**SAND CREEK - CENTER TRIBUTARY
CHANNEL ANALYSIS REPORT
FOR
SOLACE APARTMENTS**

Add PCD File No. SP201

**January 3, 2019
Project No. 25174.00**

100 YEAR FLOOD MAP
 SOLACE APARTMENTS
 JOB NO. 25174.00
 1/23/20
 SHEET 1 OF 1

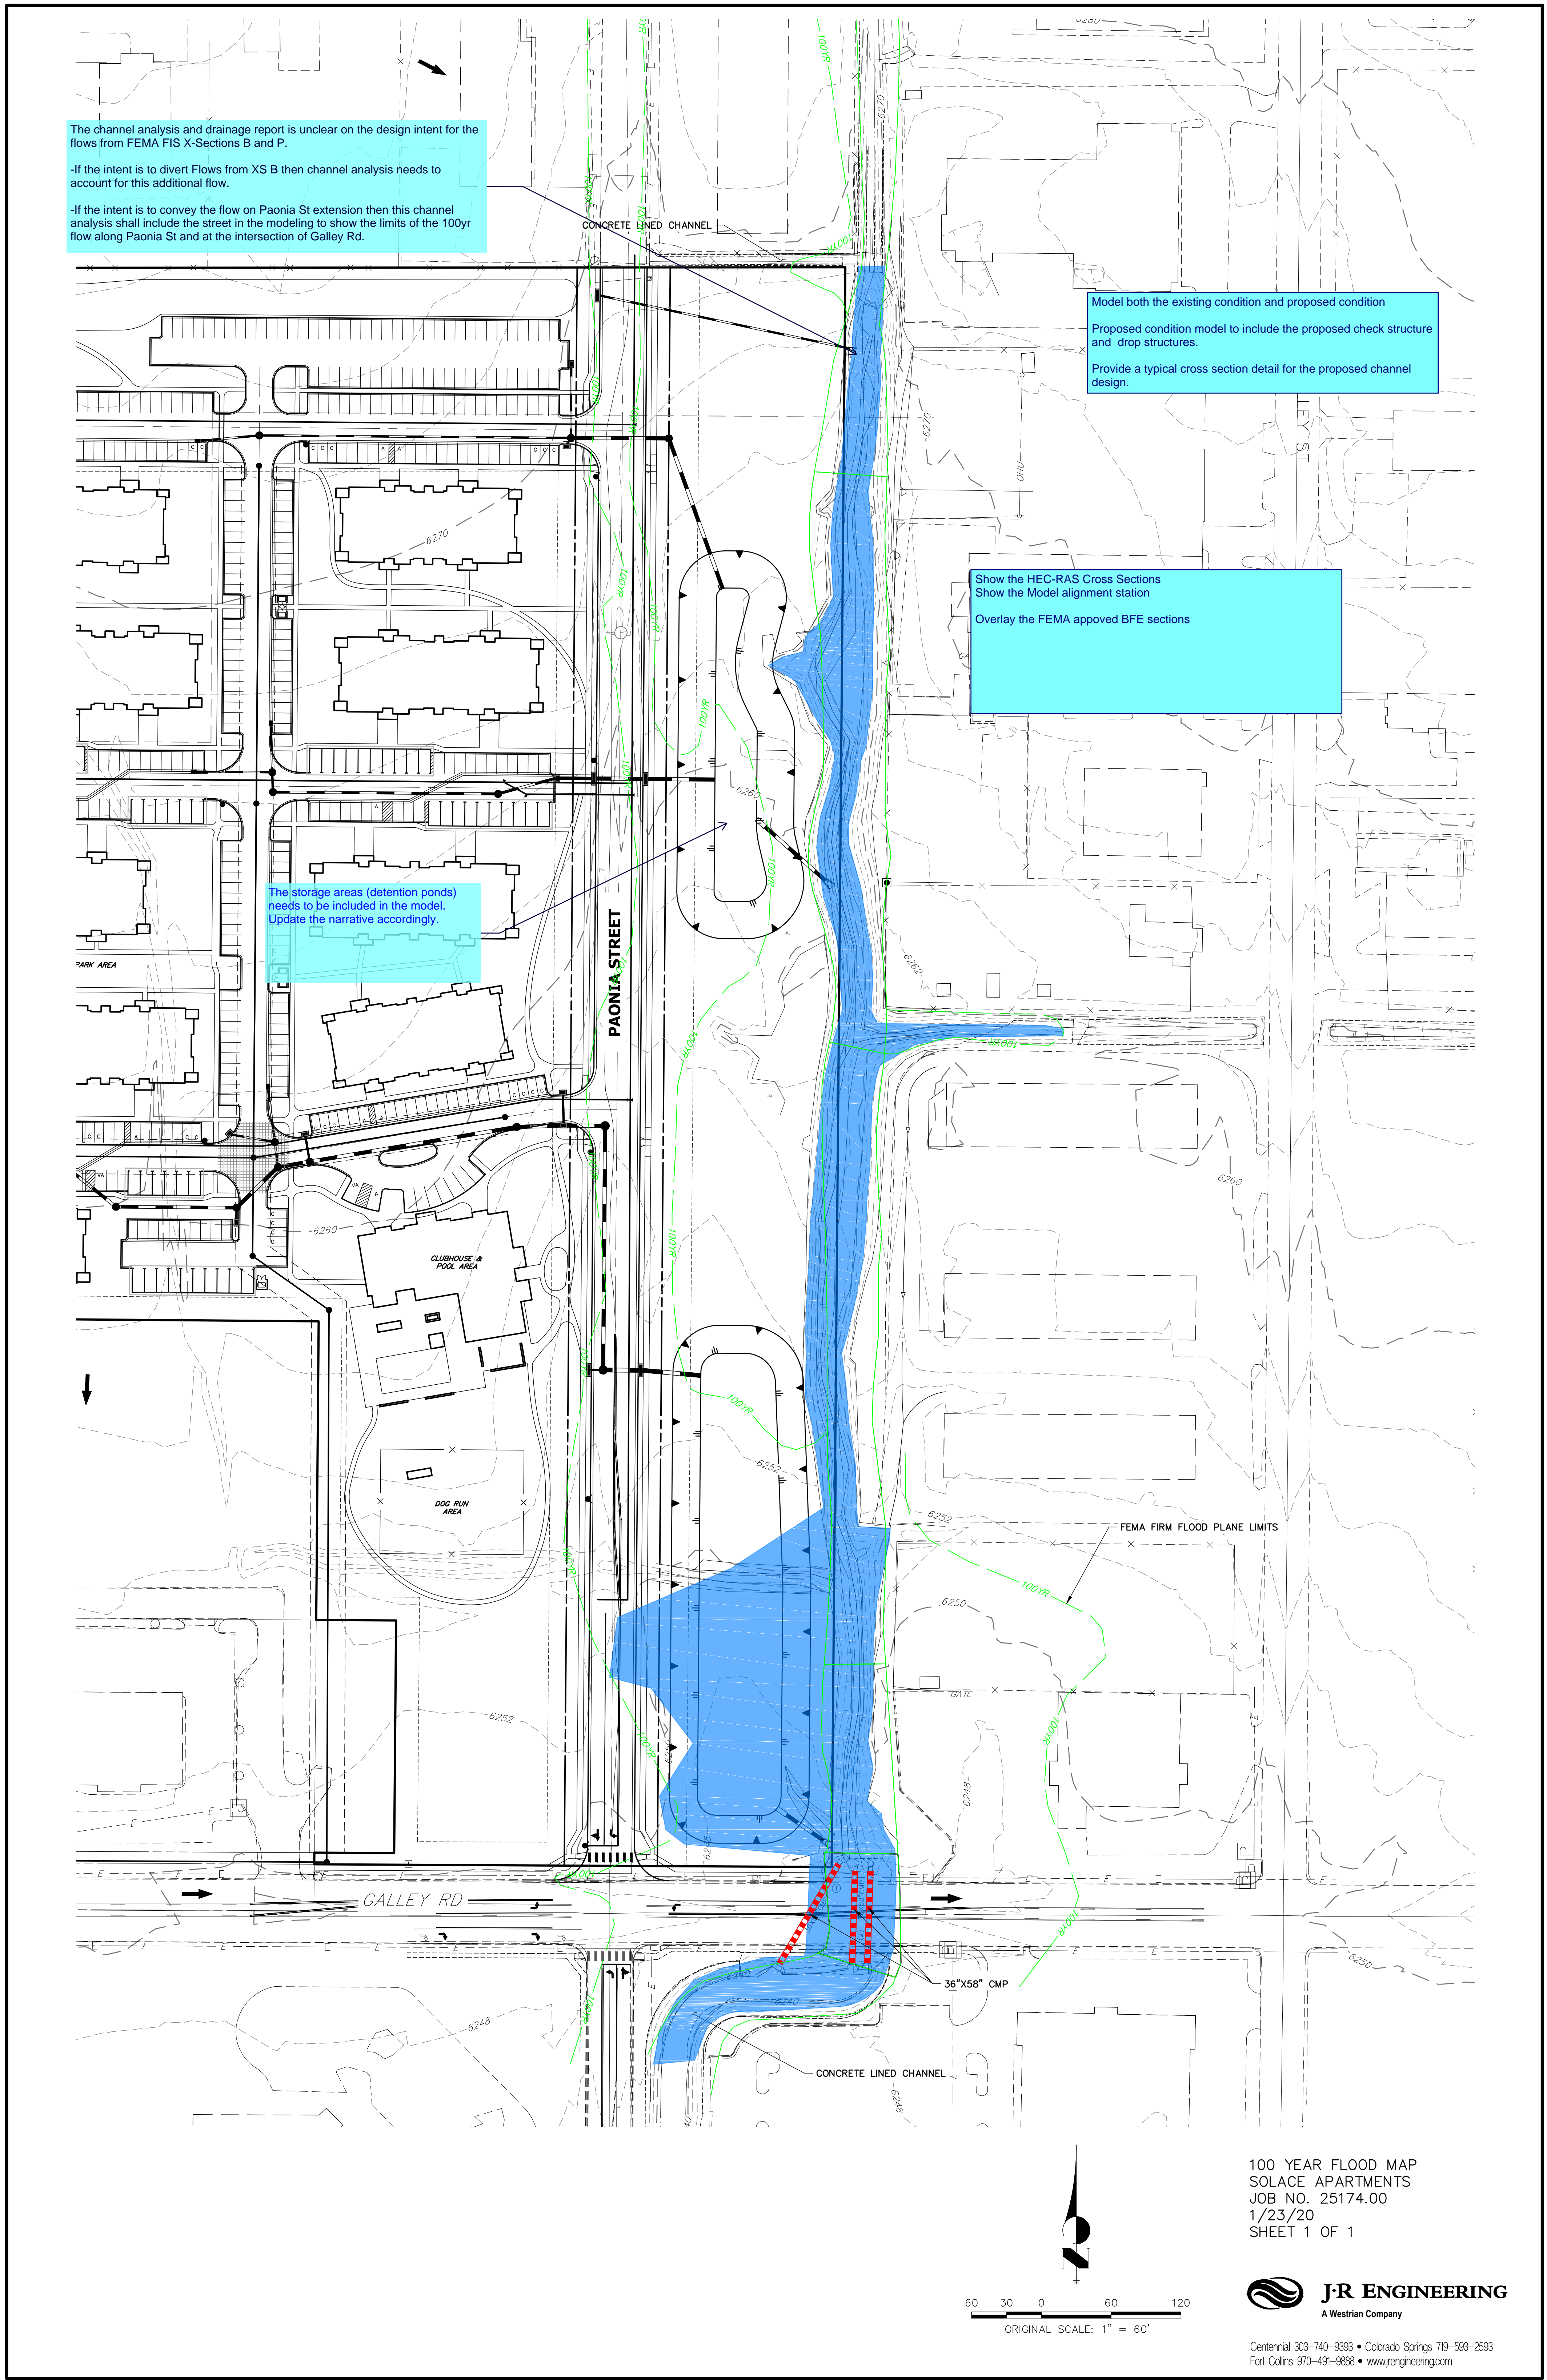
-If the intent is to convey the flow on Paonia St extension then this channel analysis shall include the street in the modeling to show the limits of the 100yr flow along Paonia St and at the intersection of Galley Rd.

Model both the existing condition and proposed condition

Proposed condition model to include the proposed check structure and drop structures.

Provide a typical cross section detail for the proposed channel design.

Show the HEC-RAS Cross Sections

Show the Model alignment station

Channel 01 CH01

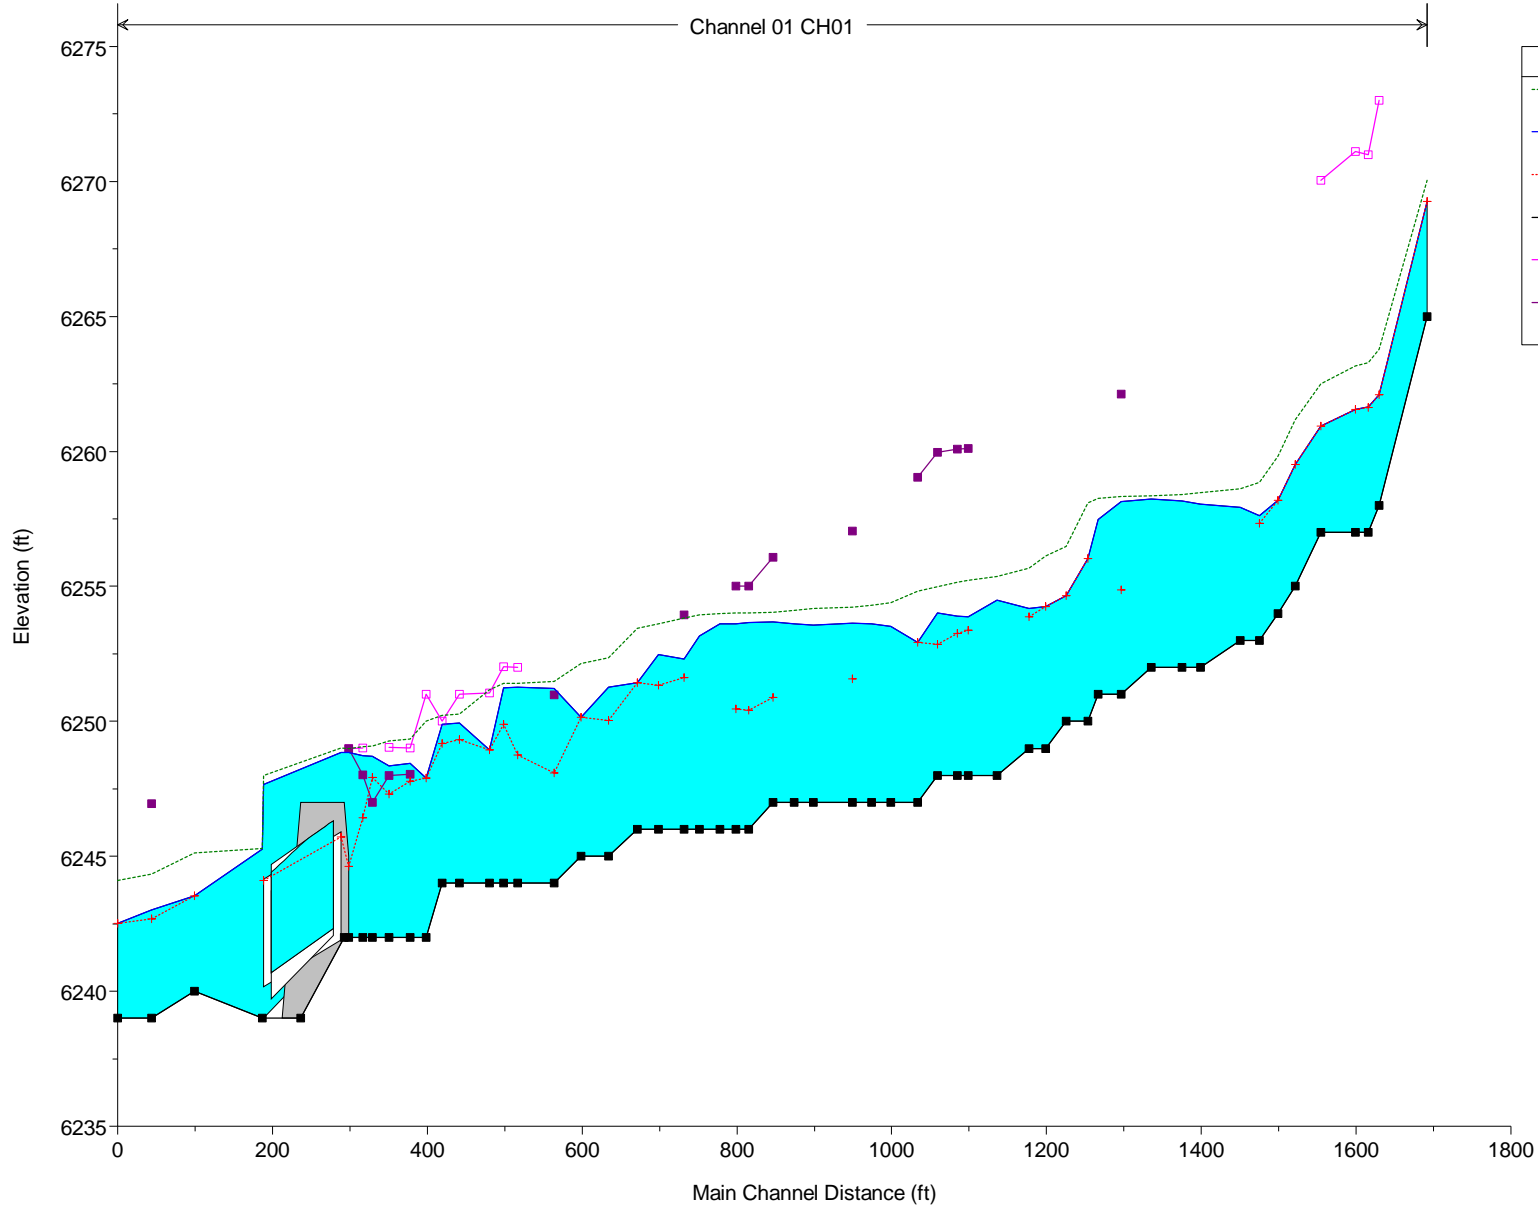
Submit the input/output data

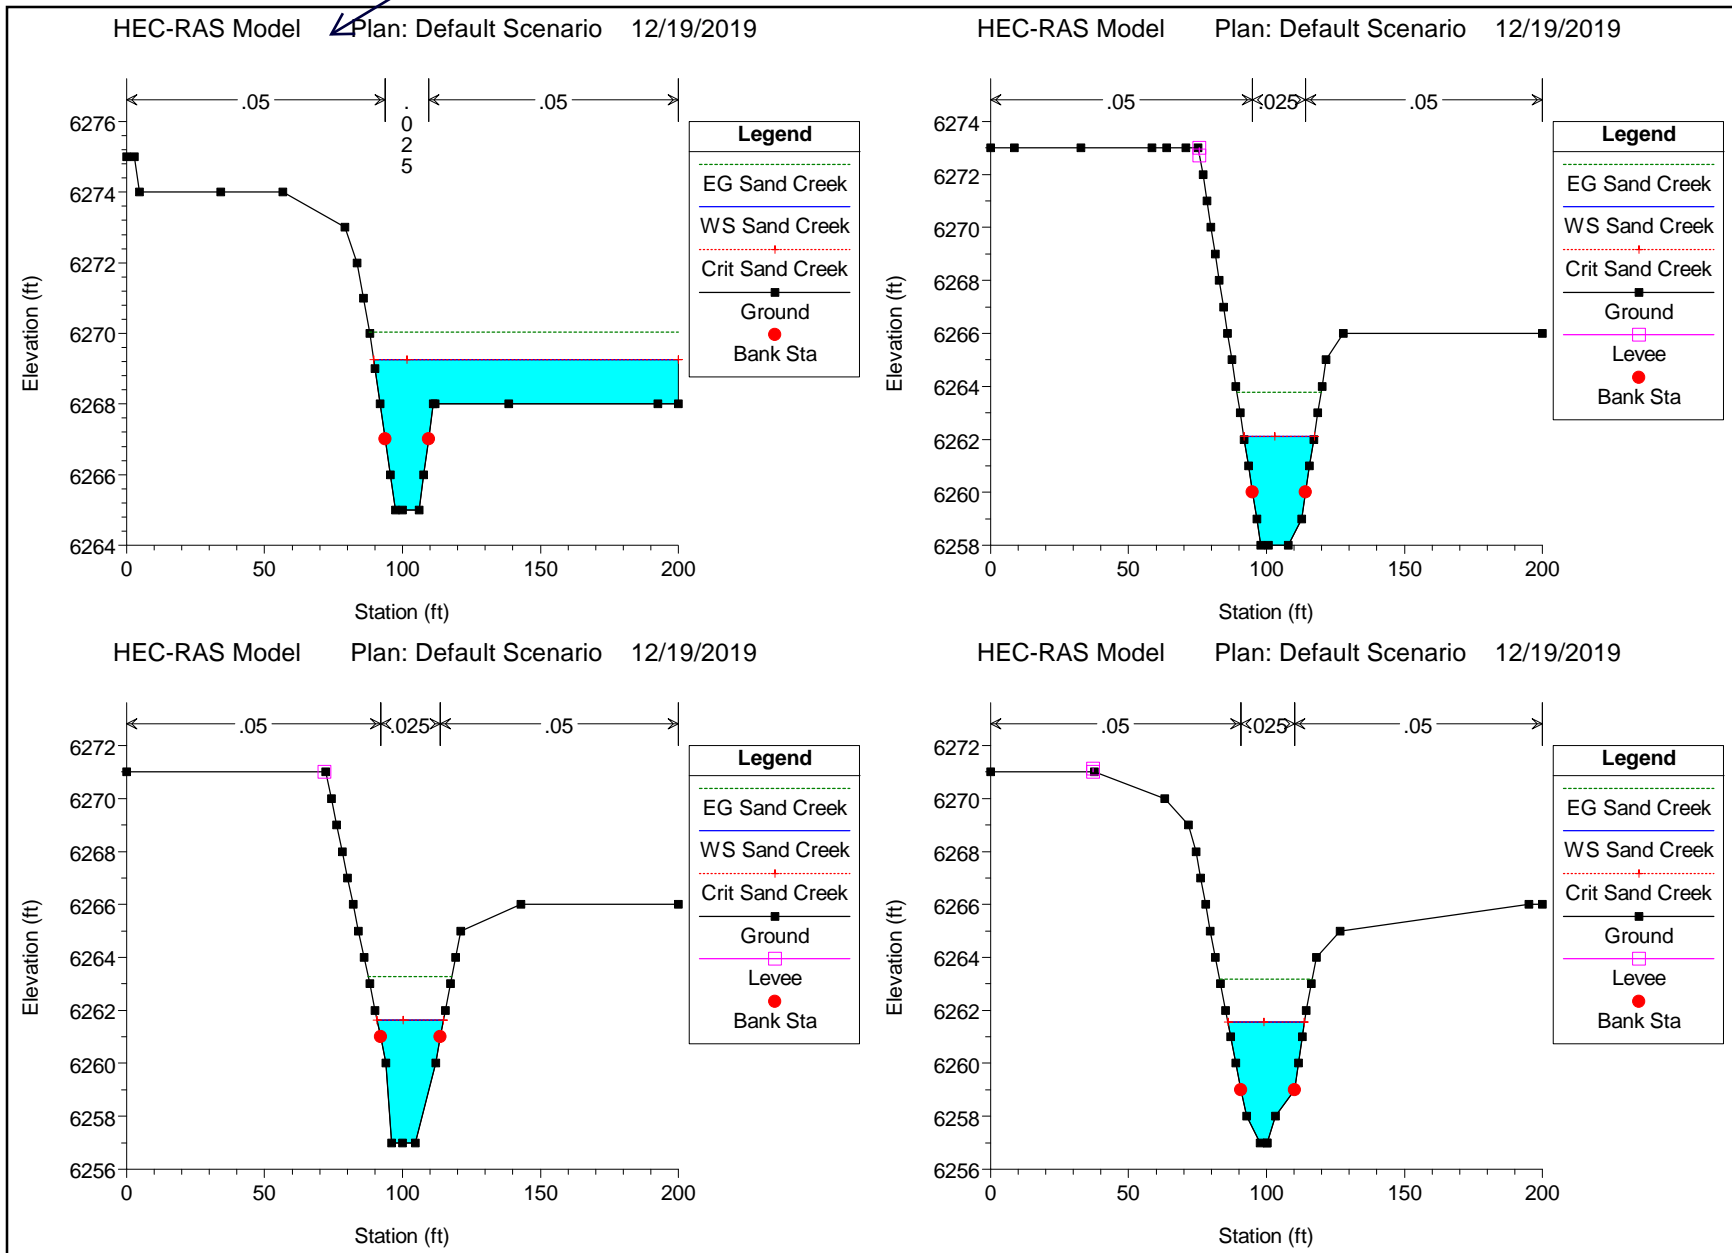
Add the river station for each cross section

HEC-RAS Model Plan: Default Scenario 12/19/2019

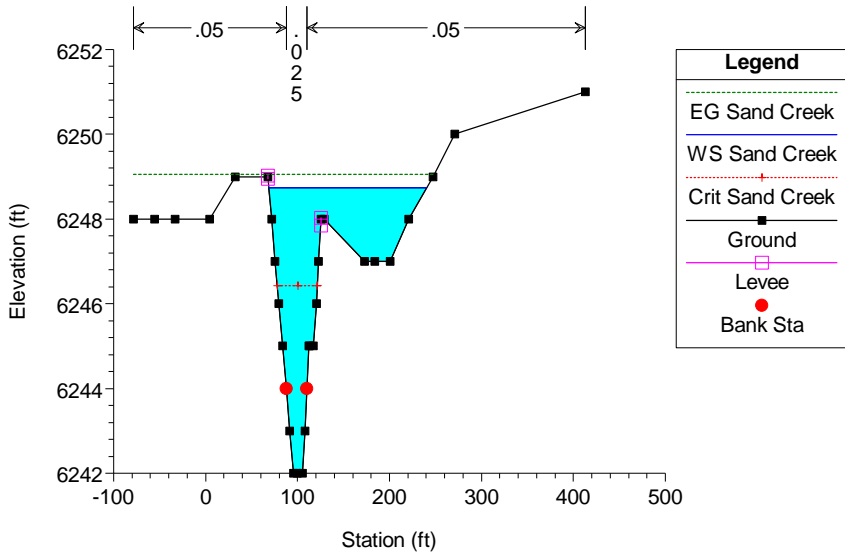
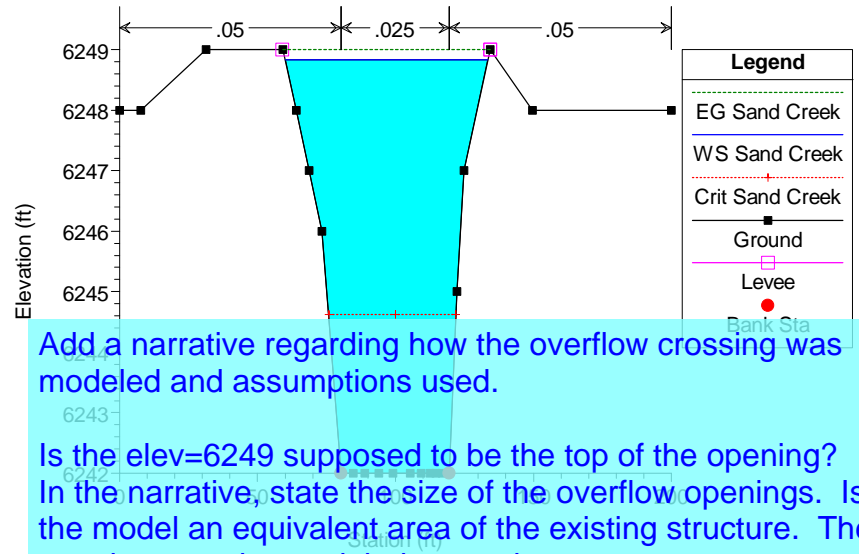
Add a narrative regarding how the overflow crossing was modeled and assumptions used.

Is the elev=6249 supposed to be the top of the opening? In the narrative, state the size of the overflow openings. Is the model an equivalent area of the existing structure. The opening must be modeled correctly.

HEC-RAS Model Plan: Default Scenario 12/19/2019

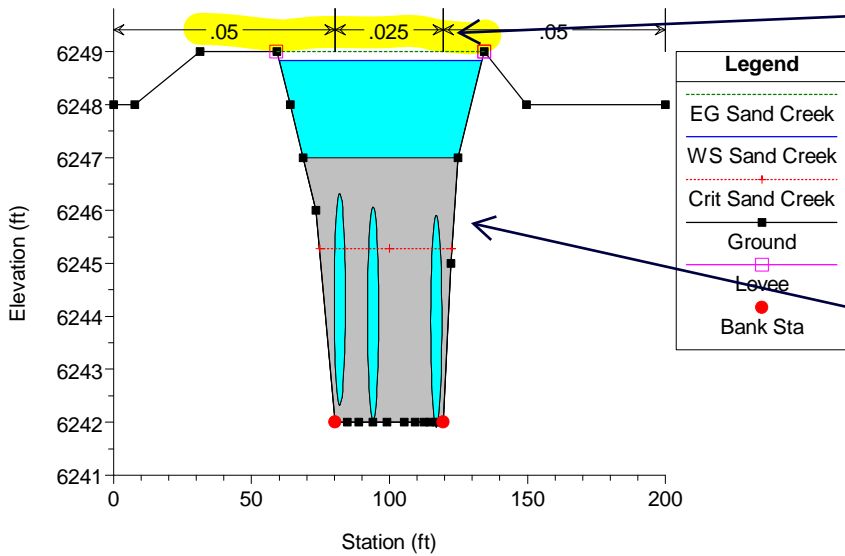
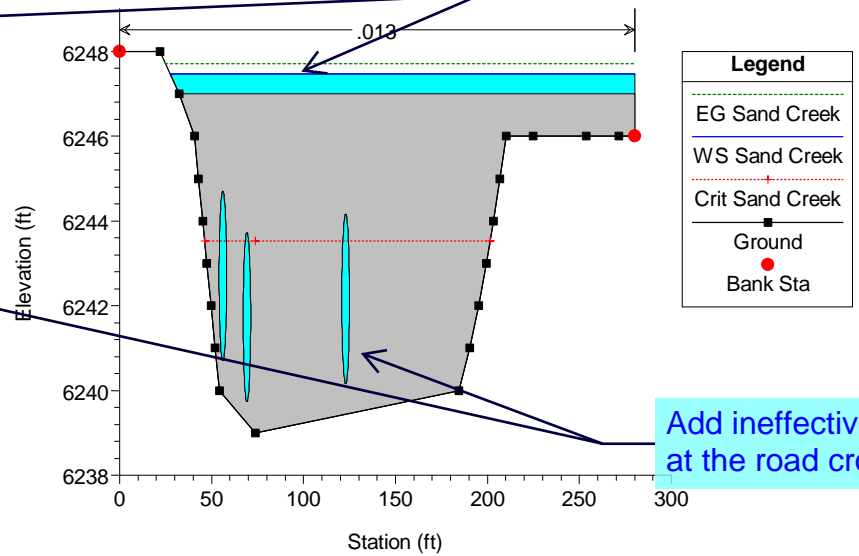
Add ineffective areas at the road crossing.
